DEPARTMENT OF CONSERVATION
AND NATURAL RESOURCES

RE: Scenic River Reviews – 2015

Project Name: Sunoco Pipeline, LP (SPLP)

Description: Sunoco Pipeline Installation

Pennsylvania Pipeline Project Proposed Construction Workspace at LeTort Spring Run

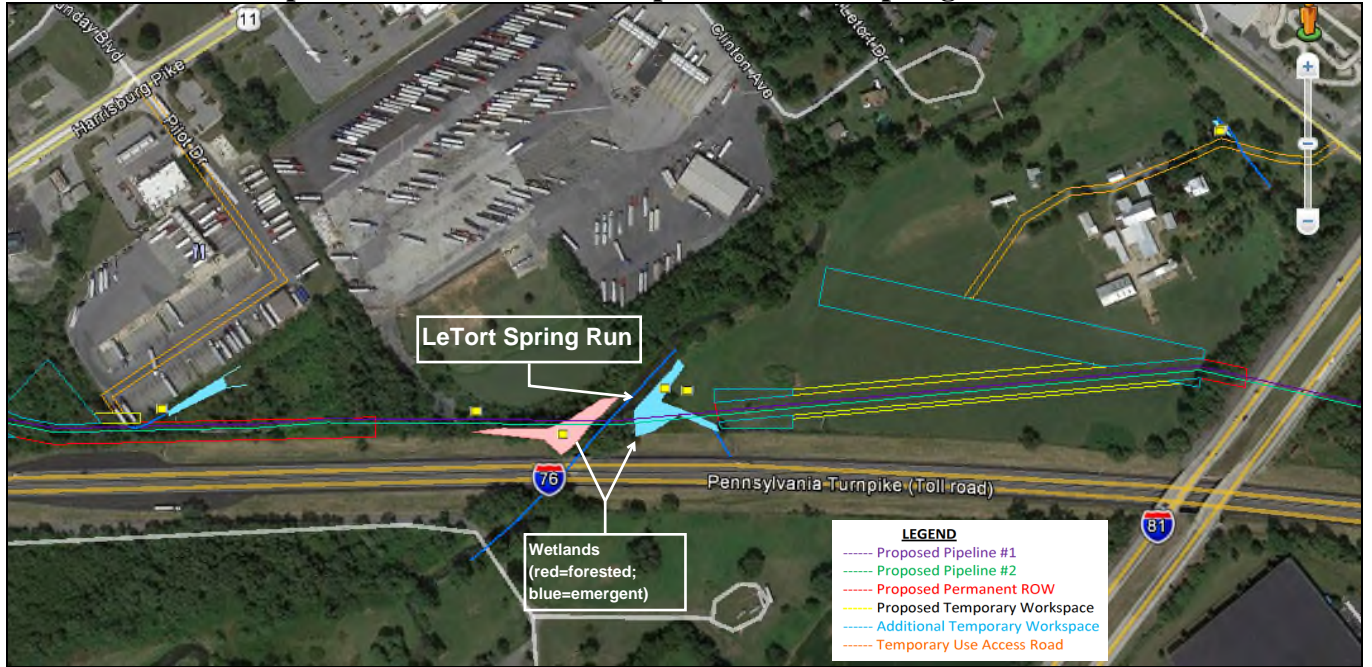
The detailed project information and proposed construction practices provided in your letter, dated July 23, 2015, are sufficient to protect the scenic and recreation values of the aforementioned waterways. Specifically, we anticipate that you will integrate the following construction practices, proposed in your letter, into the final project plans:

- No in-creek excavation or physical disturbance of the creek beds or banks.
- All construction work areas will be set back from the creek as far as possible, and those work spaces that require tree/shrub clearing will be set back from the creek bank at least 250 feet.

Attachment 2 provides the site plans at each stream crossing, showing that the proposed construction workspace is configured to set the HDD entry and exit locations well back from both streams. Specifically, the proposed construction workspaces along the ROW would avoid the immediate vicinity of LeTort Spring Run; they would be set back approximately 570 feet west and 250 feet east of the stream banks along the ROW. No clearing would occur between these workspaces (see Attachment 2). The proposed crossing location at LeTort Spring Run is parallel and adjacent to the Pennsylvania Turnpike crossing of this stream, and adjacent to a truck terminal facility. A separate workspace is proposed within 45 feet of LeTort Spring Run, located north of the ROW (east side of the stream), to accommodate stringing a length of pipe install beneath the nearby Interstate 81 highway. This workspace is located in an open agricultural field, and no tree or shrub clearing would be necessary. This use of this workspace will be temporary (only for the duration of construction in this area), and the area will be restored to original use and appearance following construction, avoiding any long-term changes to the visual character or context adjacent to the stream.

Pennsylvania Pipeline Project Proposed Construction Workspace at Yellow Breeches Creek

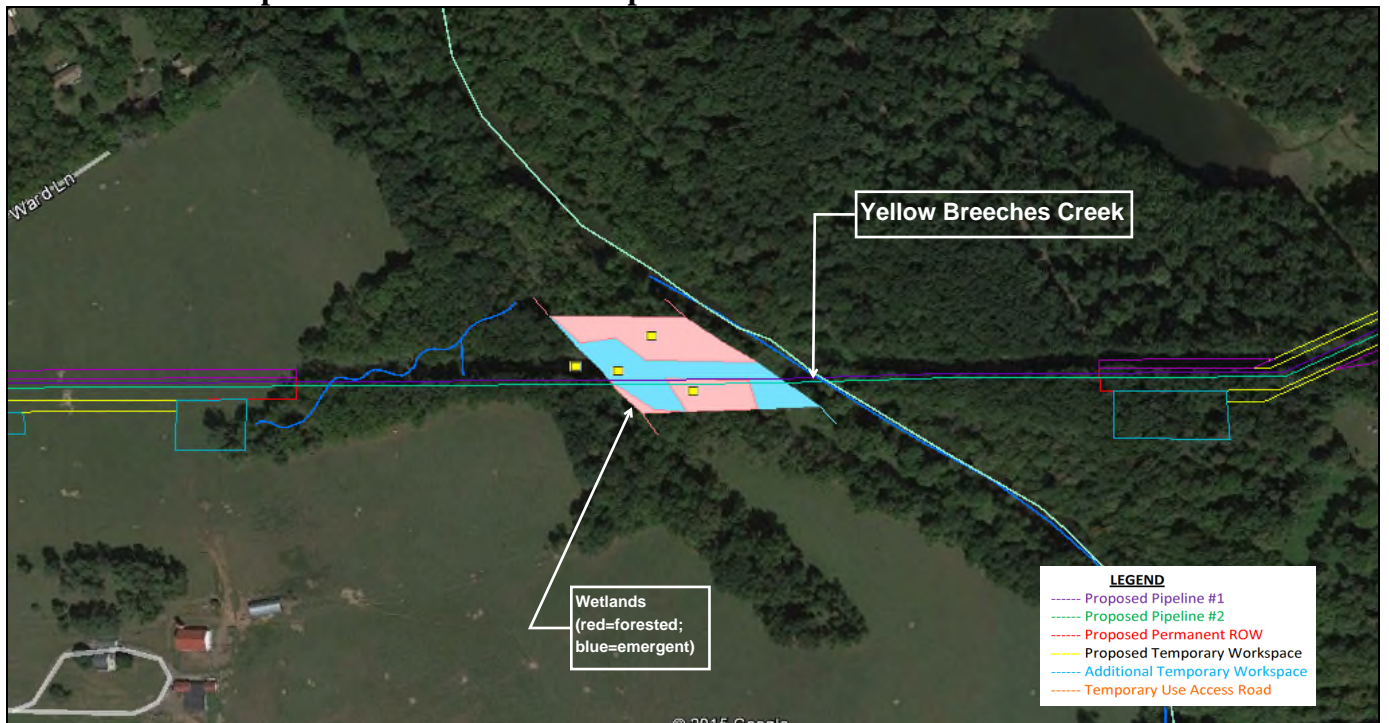
Similarly, the proposed construction workspaces would avoid the immediate vicinity of Yellow Breeches Creek. The proposed workspaces would be set back approximately 1,230 feet west and 570 feet east of the stream banks, measured along the ROW (see Attachment 2). No clearing would occur between these workspaces.
